**Eastonville Road – Londonderry Dr. to Rex Rd.  
Segment 2 Improvements  
Stationing 47+00.00 – 79+31.62**

**Final Drainage Report**

January 2025

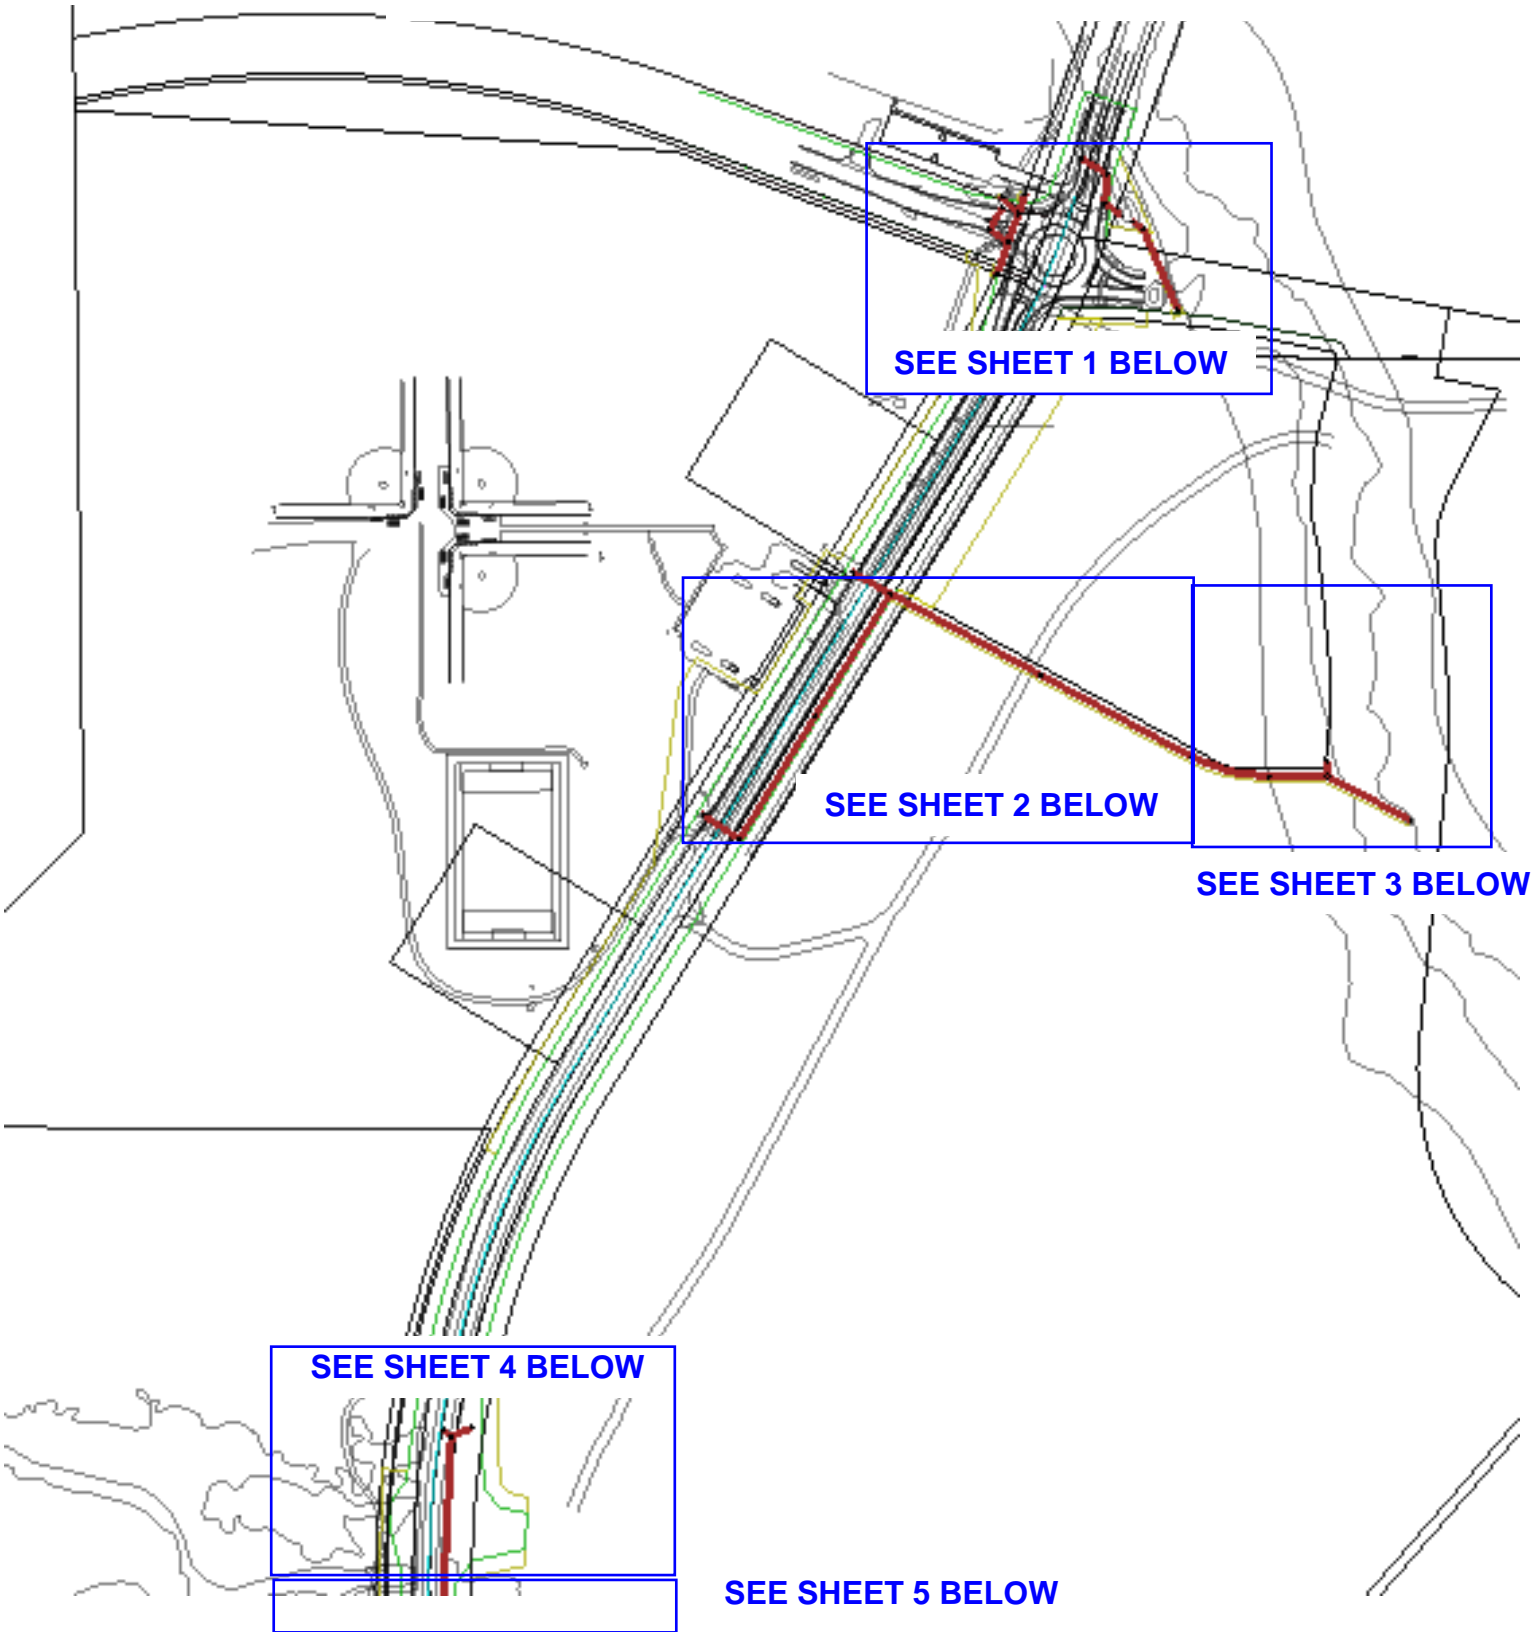
Unresolved:  
Provide calculations for Pond B spillway riprap sizing.

EXISTING CONDITIONS - DRAINAGE MAP  
 SHEET DRN 2

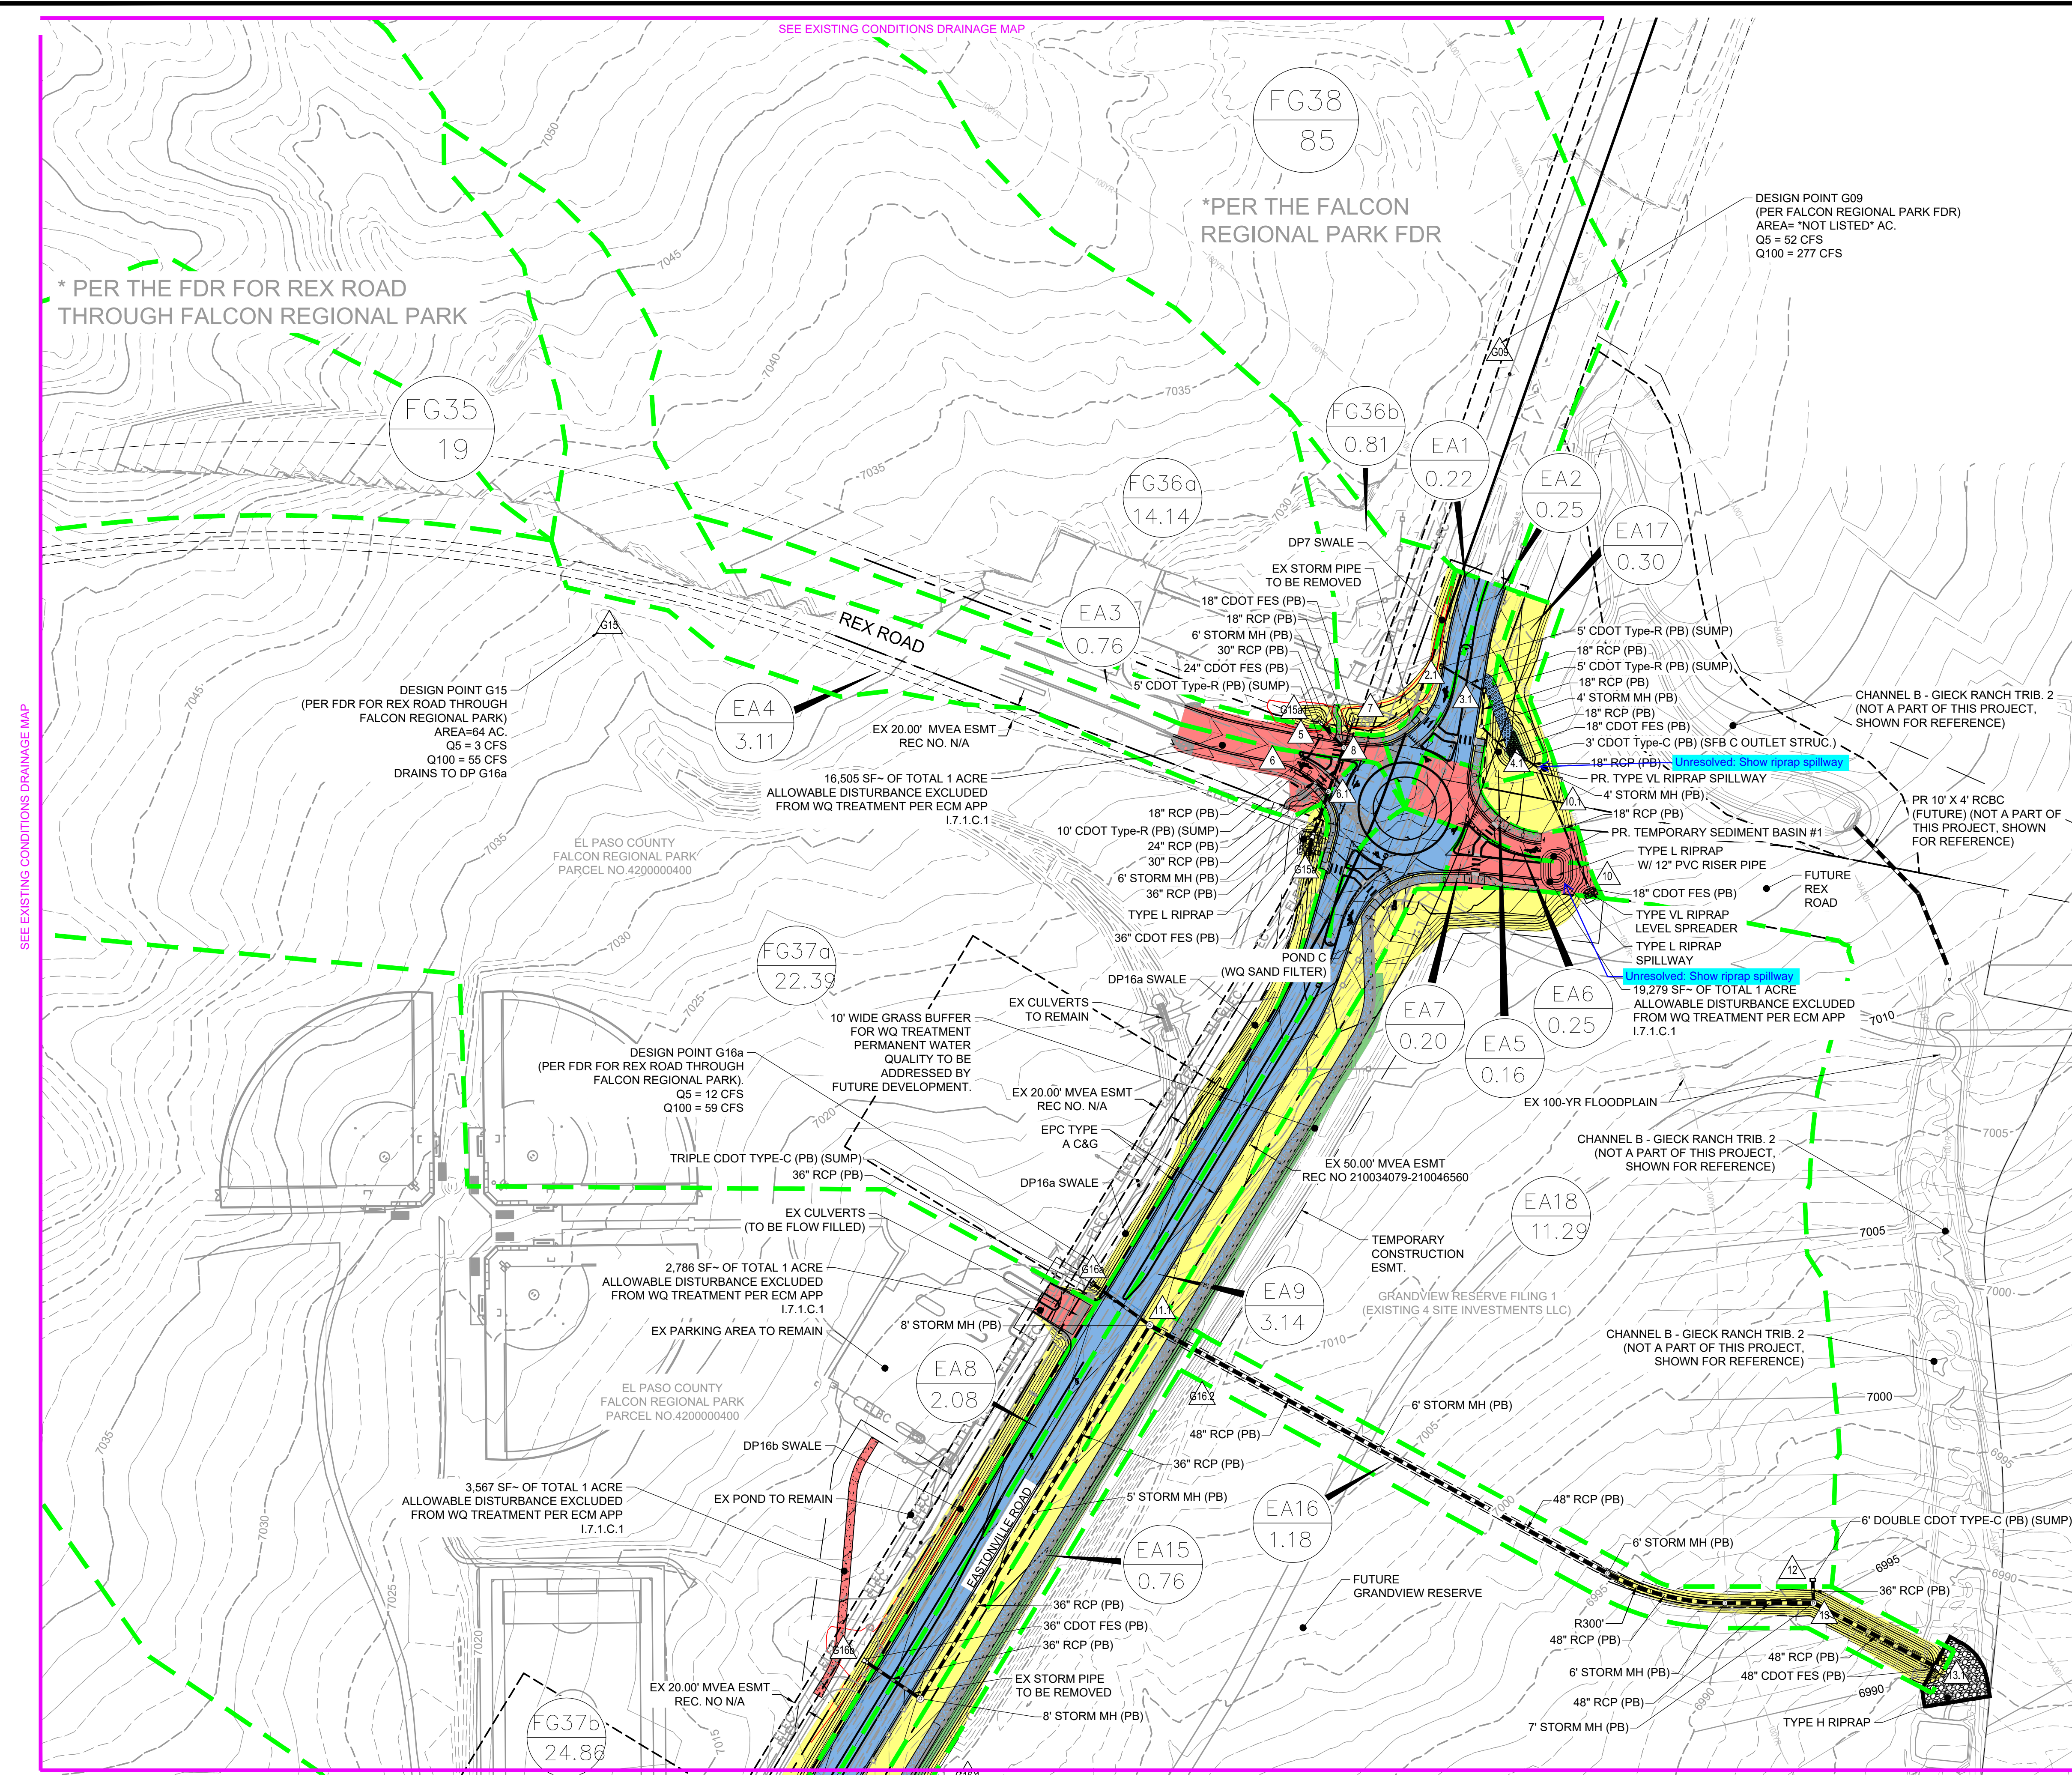
Provide a Legend for the shading colors on this map, like was done with the Segment 1 FDR Drainage Maps
